**Shadrick Creek Restoration Project**  
**Annual Monitoring/Closeout Report**

Shadrick Creek Stream Restoration Project  
NCDMS Contract No. 7343  
NCDMS Project No. 92916  
DWR# 10-0465v2  
USACE Action ID: 2010-00764  
McDowell County, North Carolina  
Data Collected: April 2022 – November 2022  
Date Submitted: December 2022

Subject: RE: Draft MY5 Monitoring Report  
Review for the Shadrick Creek Restoration Project  
Catawba River Basin – CU# 03050101  
McDowell County, North Carolina  
NCEEP Project # 92916  
Contract No. 7343

Shadrick Creek - UT9  
 Longitudinal Profile  
 Stationing 19+59 to 22+08

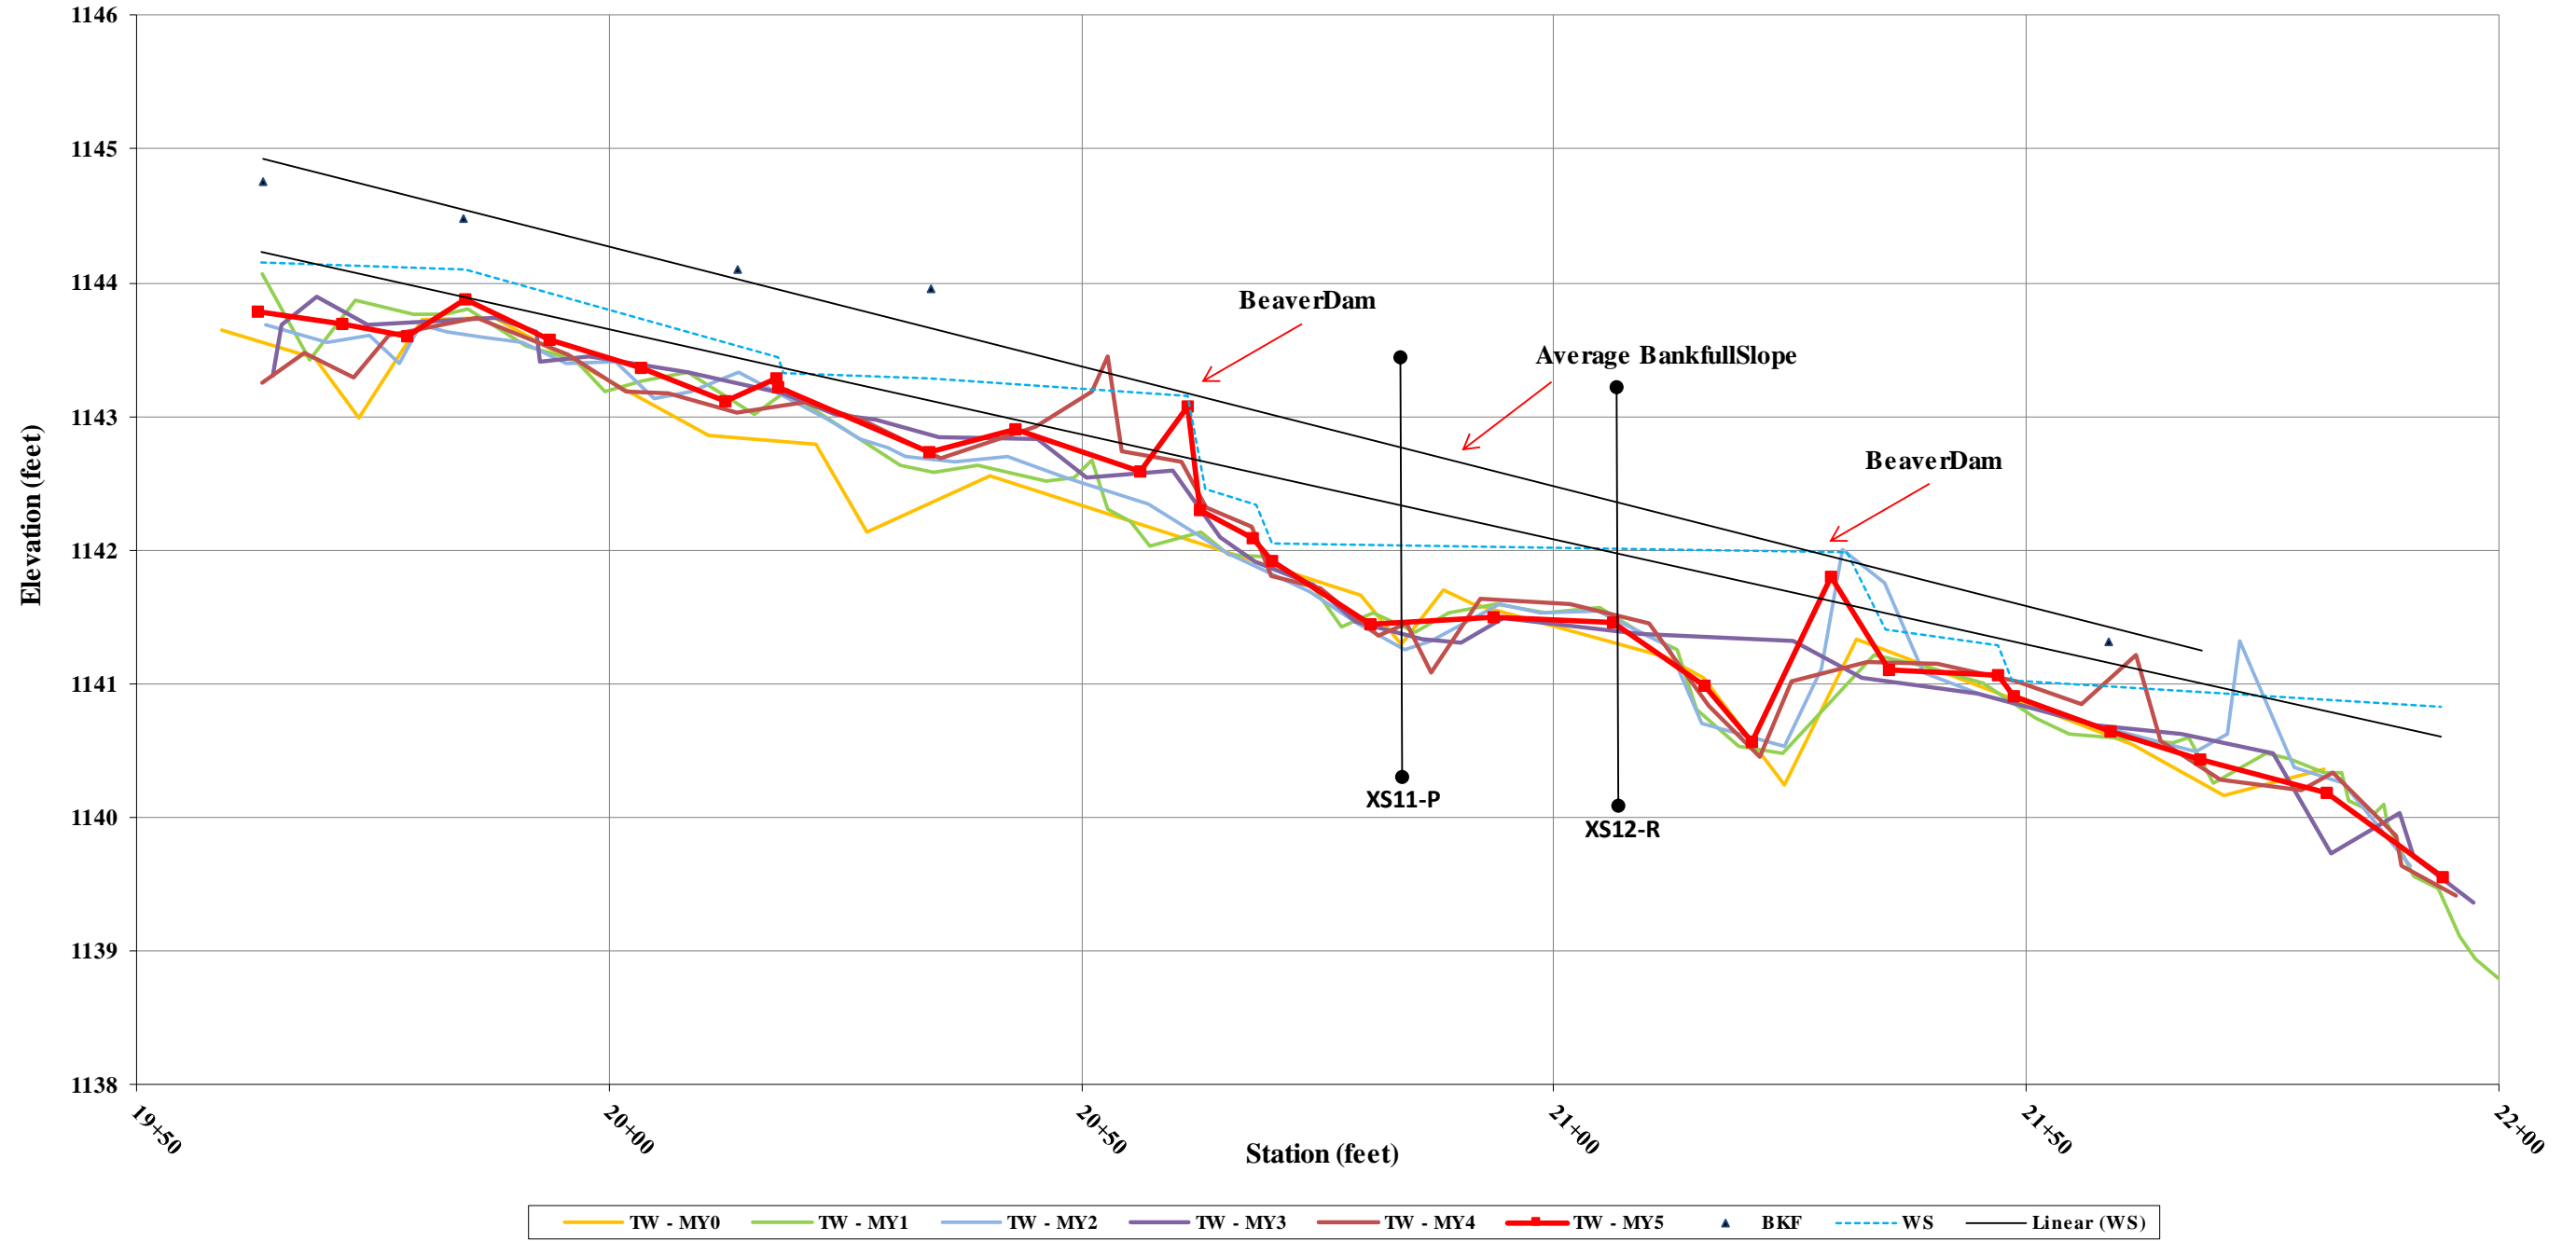
- CCPV: Please include beaver dam locations on UT9 Reach 2. There are two locations identified on the profile survey. **CCPV revised.**
- Photo Point 7: Upstream and downstream photo reference UT7. This should be UT5. Please revise. **Revised**
